# PLANNING COMMISSION STAFF REPORT

## View Street Mixed Use Subdivision & Planned Development PLNSUB2011-00196 & PLNSUB2011-00307 1325-1339 E 2100 South, and 2004-2012 View Street Public Hearing: July 13, 2011

1 SITE PLAN  
Scale: 1/20" = 1'-0"

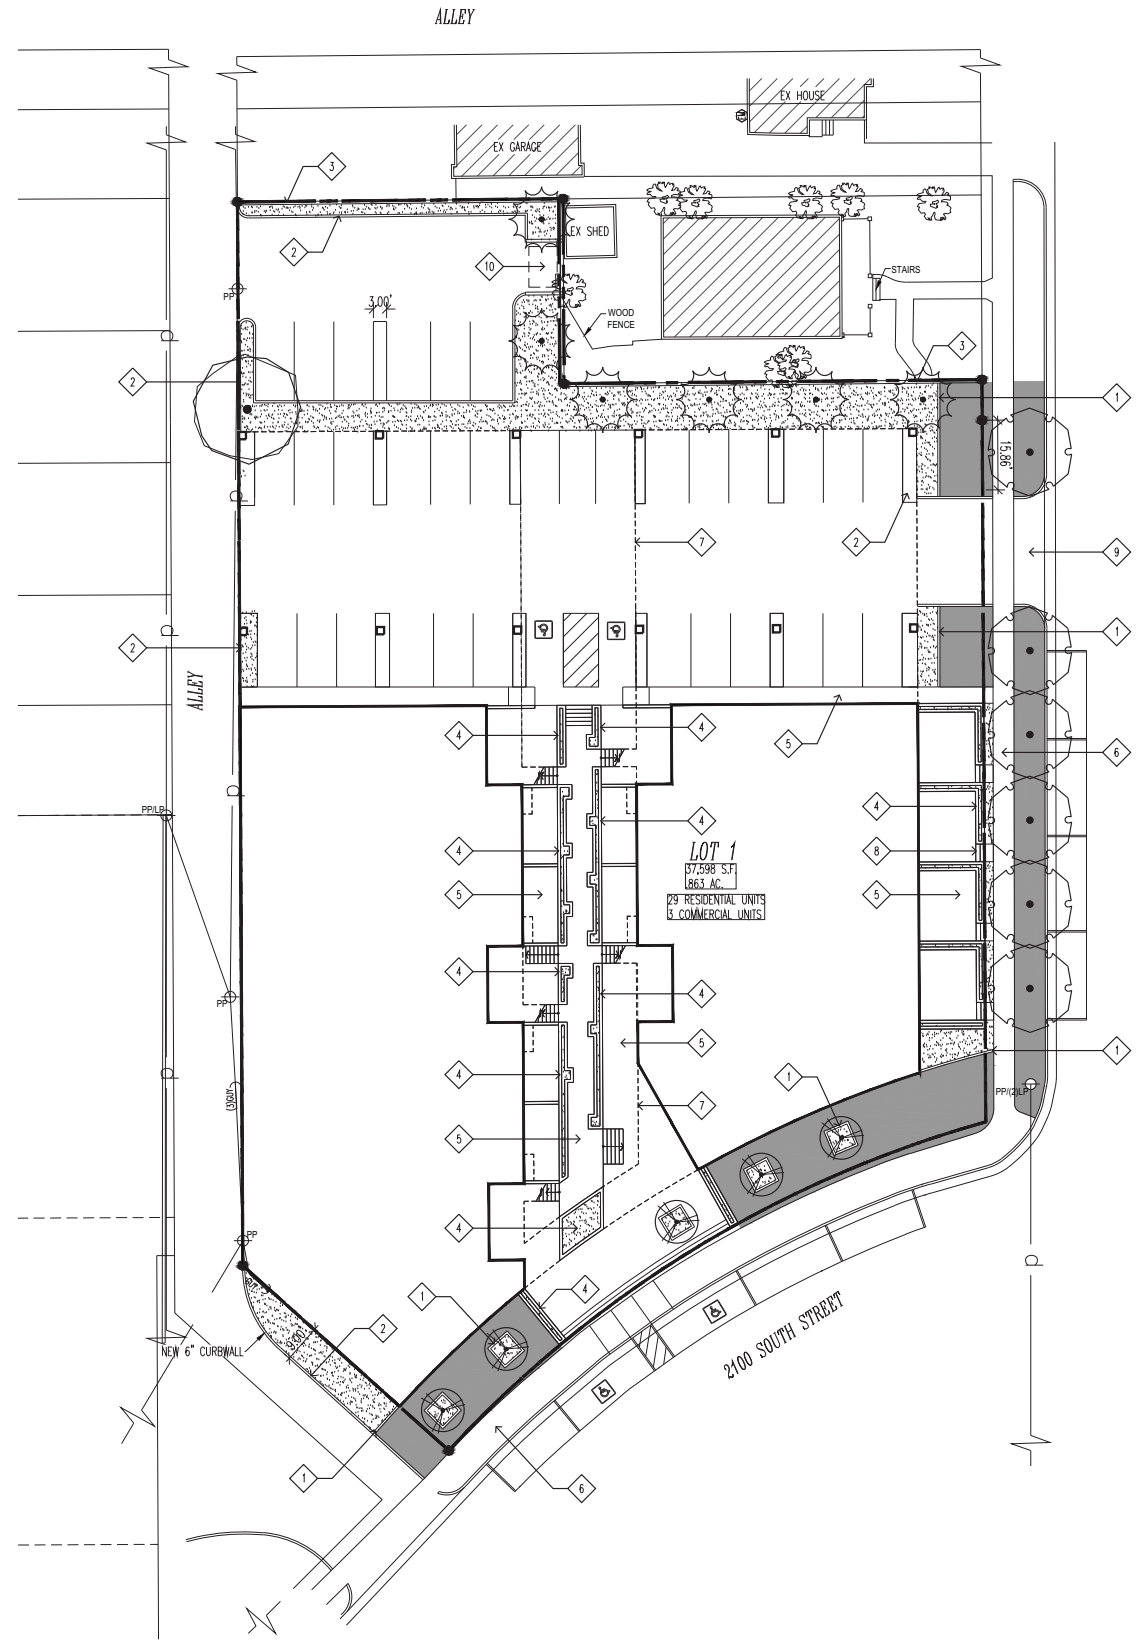
**Comments:** The proposal indicates 29 residential units and 4 commercial units with 35 on site parking stalls two being ADA stalls and 9 on street parking stalls shown. The on street ADA stalls are not compliant as shown. Please provide additional dimensions to fully review the proposed parking layout and pedestrian circulation (ADA corridors, height clearances, etc.) Provide parking calculations for each designation along with ADA and 5% bike stall provisions and details and PLNSUB2011- 00196 To create one lots no change to public ROW.

- 5) Consider whether the dumpster is properly located in a required landscape buffer area.
- 6) Consider if the recessed patios located in the required corner-side yard setback require grade changes exceeding two feet and if so, should this be address through the planned development process or as a special exception.

SHEET TITLE:  
**PRELIMINARY LANDSCAPE PLAN**  
**L0.01**  
 SHEET 1 OF

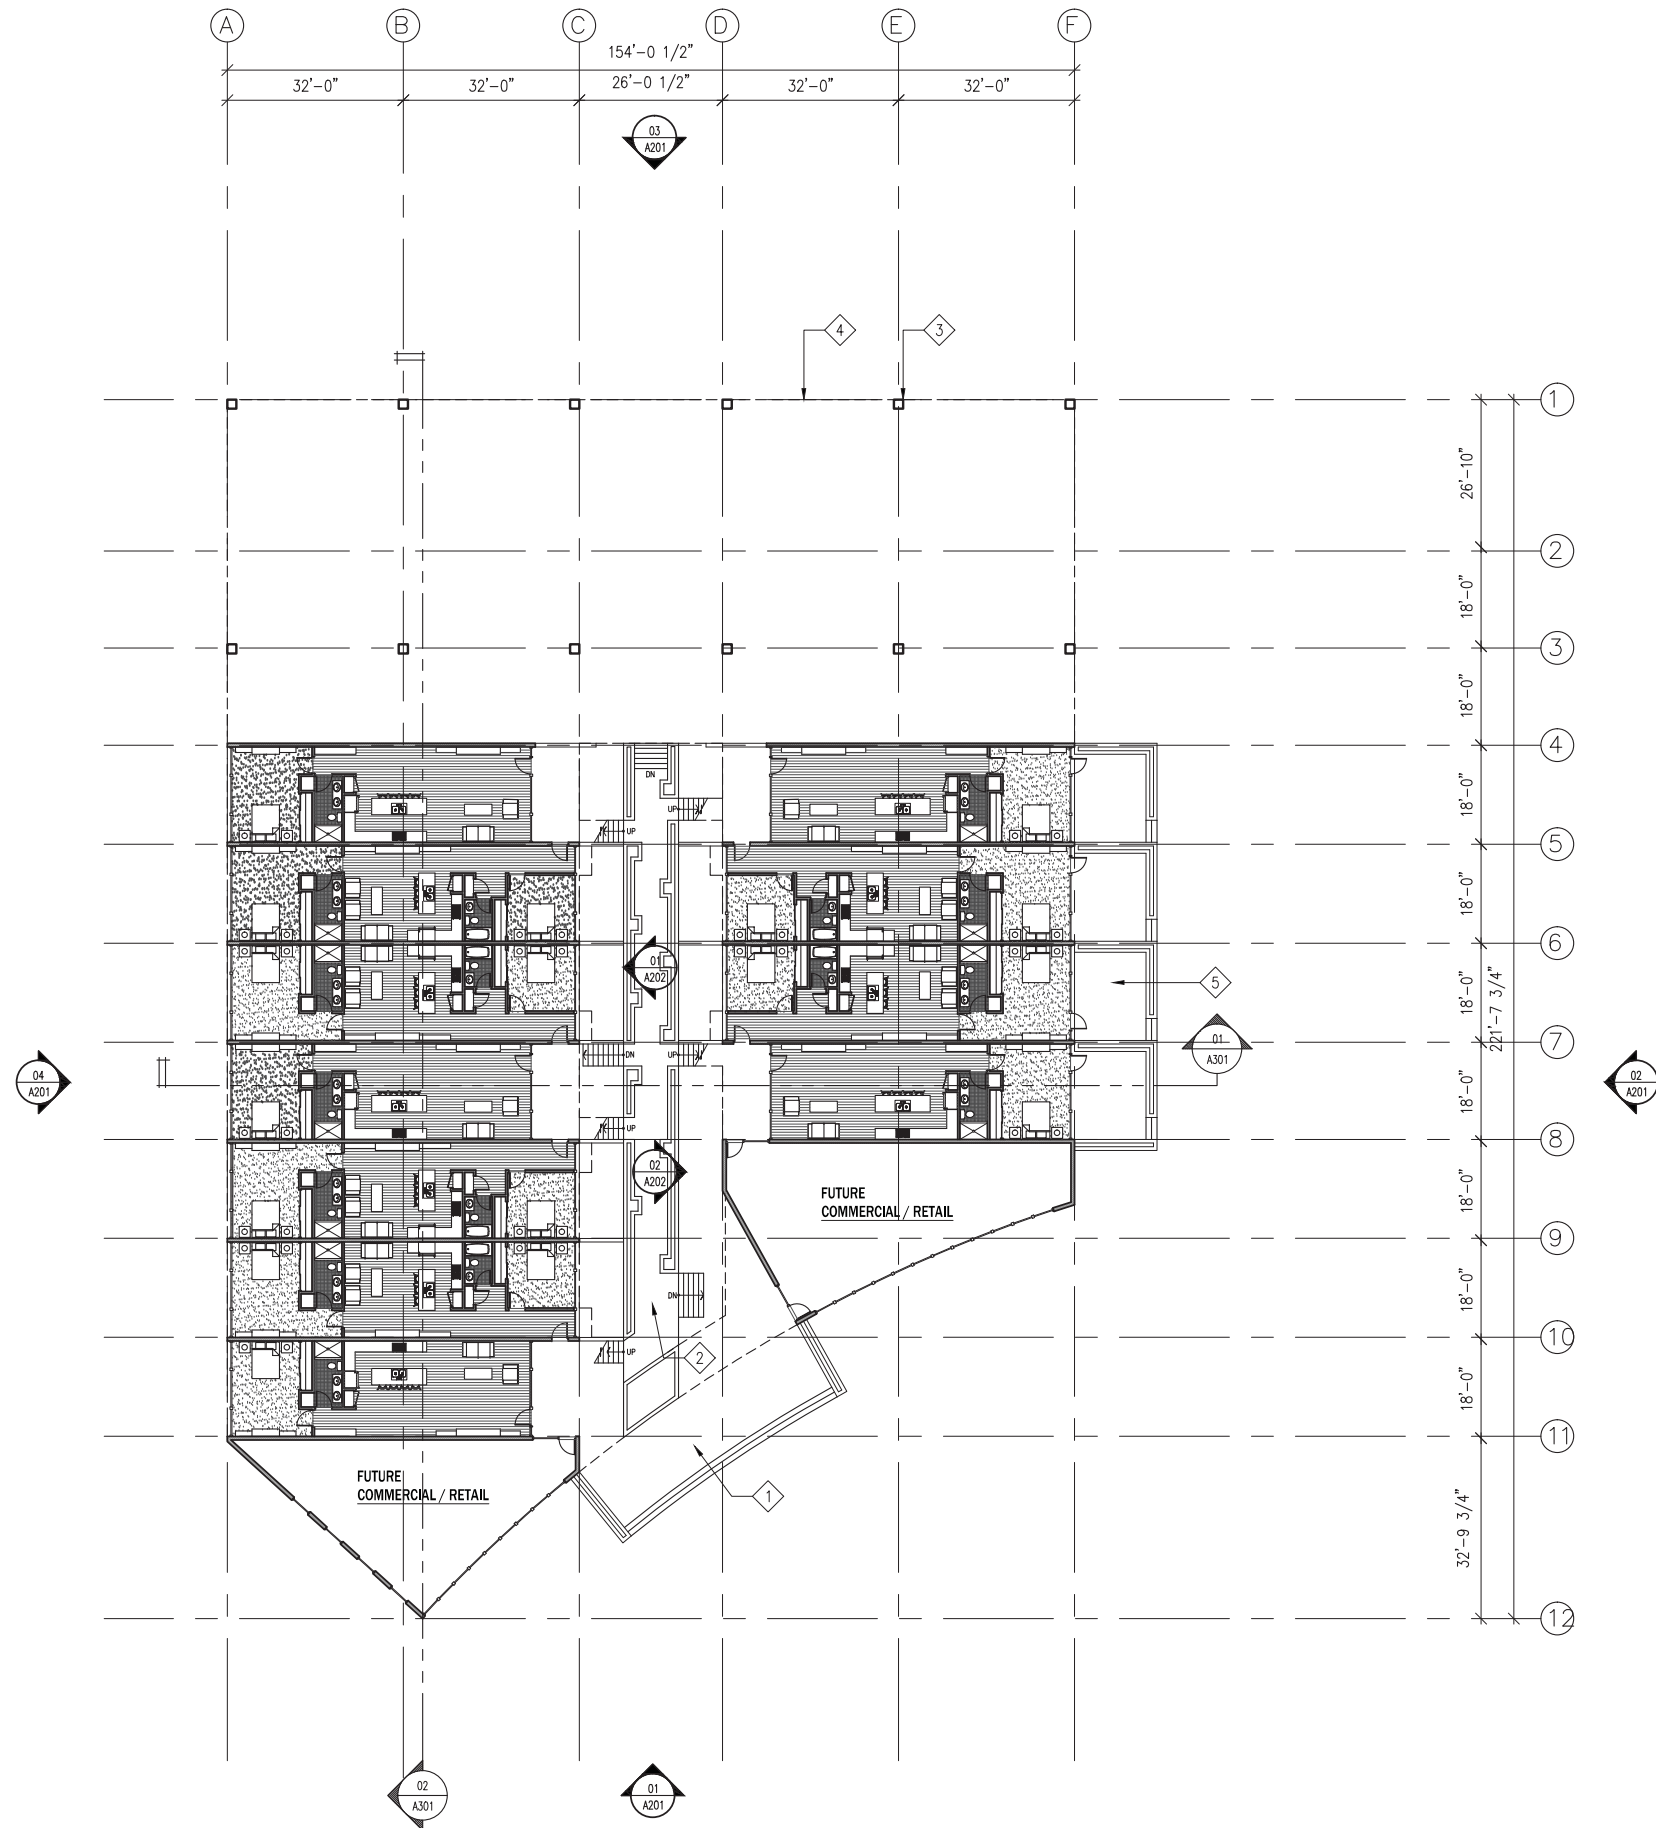
**Finding:** Proposal does not sufficiently comply with this standard. Staff recommends the applicant submit a landscape preservation plan—where feasible—to the Planning Director for final review and approval.

- 7) Consider whether the minimum 1/3 living vegetation requirement for the corner-side yard has been met as per 21A.48.090, or should this be addressed by the planned development process. Percentage or require corner-side yard landscaping has not been provided on the plans.

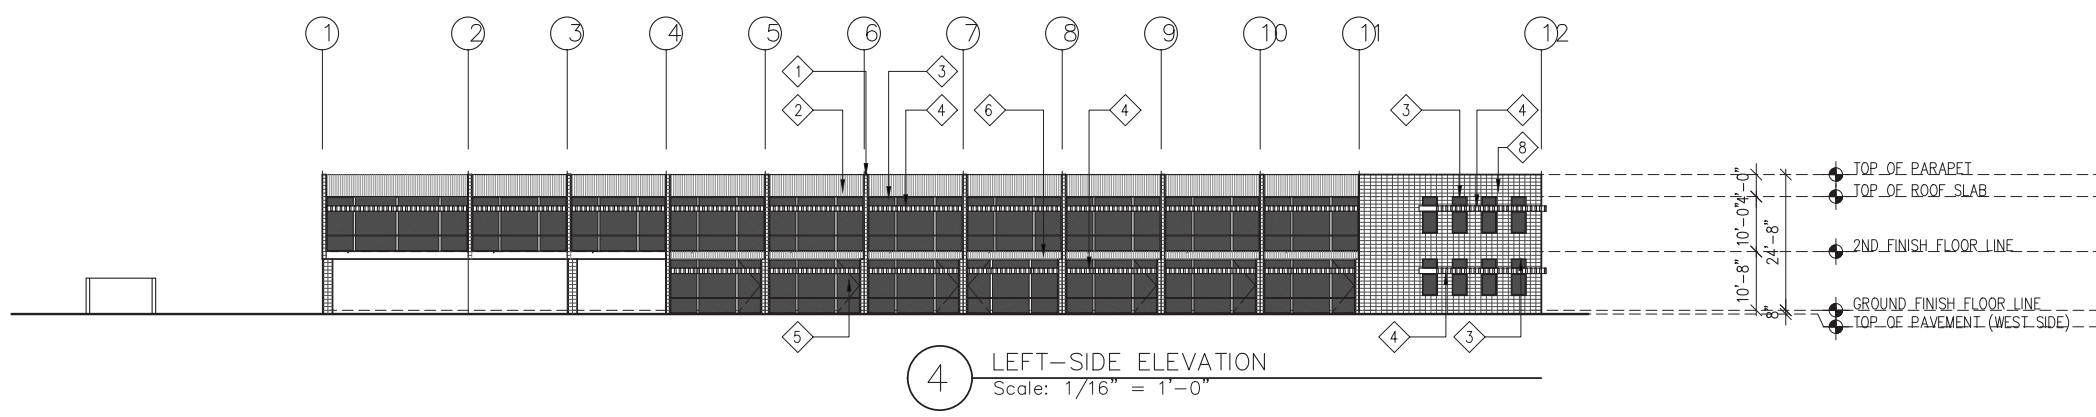
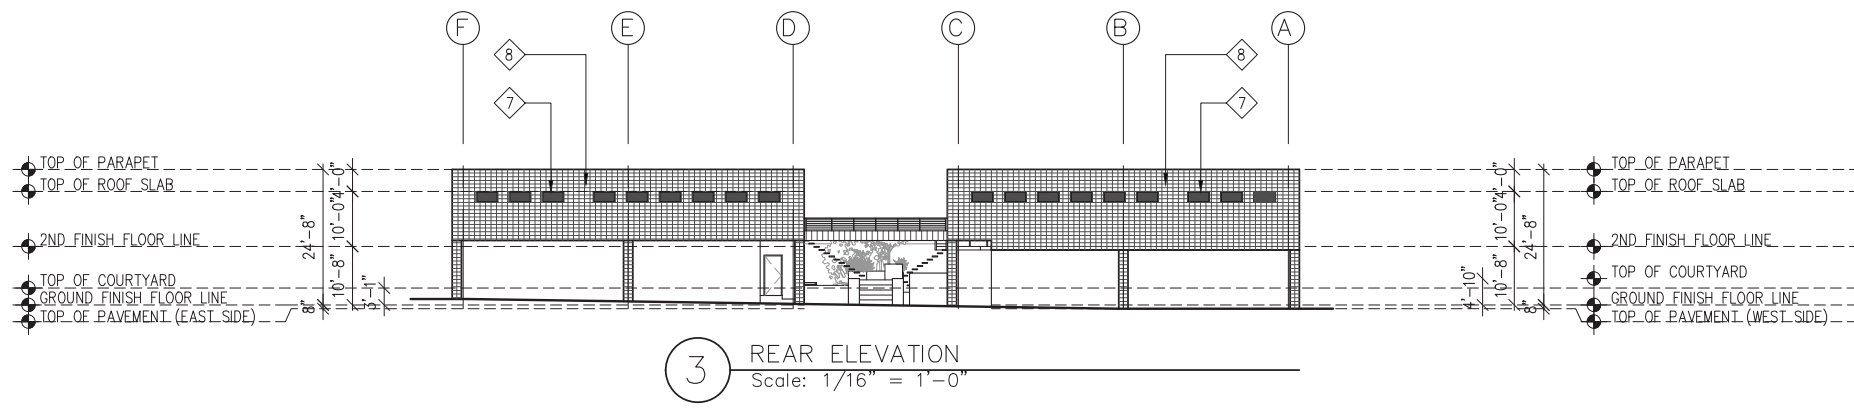
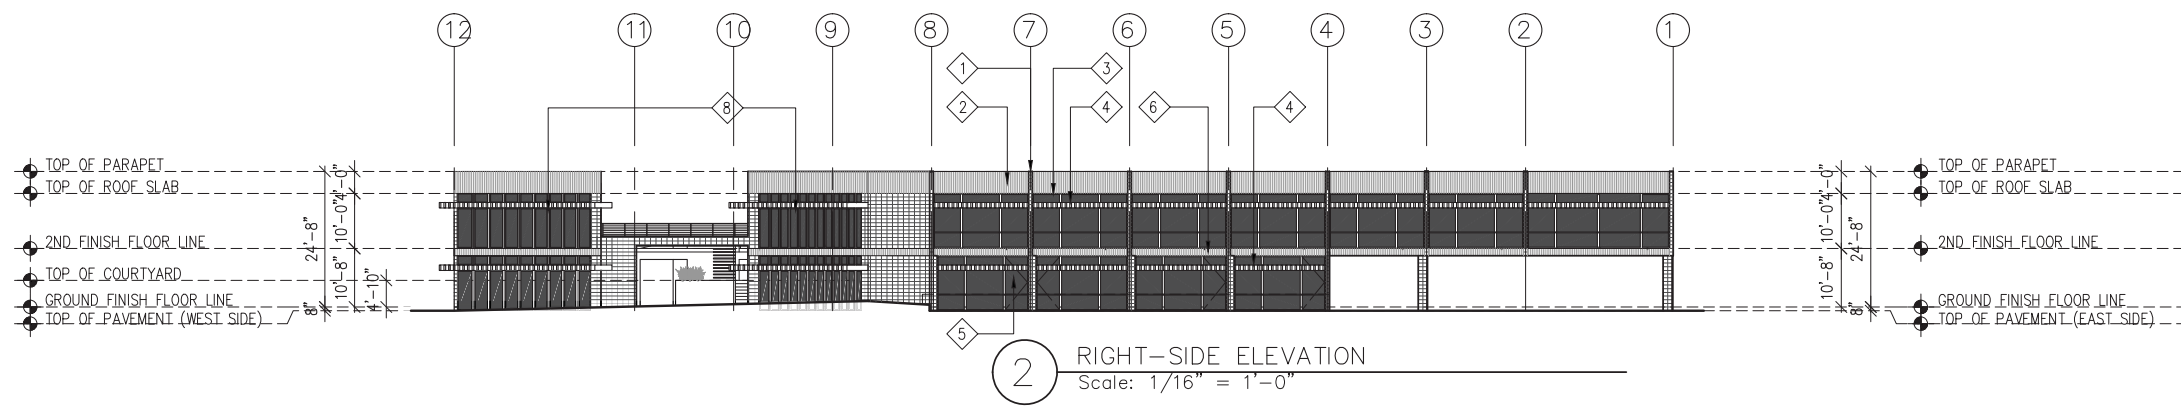
Most of the comments that we heard related to the architectural style, and the choice of materials. I received a number of comments from trustees after the presentation. While the architect chose the style by drawing from the context of the buildings along 21<sup>st</sup> South from 13<sup>th</sup> East to the east, our

participants don't think that really represents what we like to see in Sugar House. We like traditional brick buildings. This looks like mid-20<sup>th</sup> century architecture that doesn't have much that is special about it. We are pleased that as the plans evolve for this building, the materials are evolving. They will use something more durable for the awnings and railings than the wood that was previously shown. The roof lines will change; the building entrances will be more defined.

- 8) Consider that plans do not indicate the type of glazing to be used and 1<sup>st</sup> floor glass calculations have not been provided on the plans to show compliance with the visual entrance requirements for percentages of 1<sup>st</sup> floor non-reflective glass pursuant to 21A.26.020.I.1.
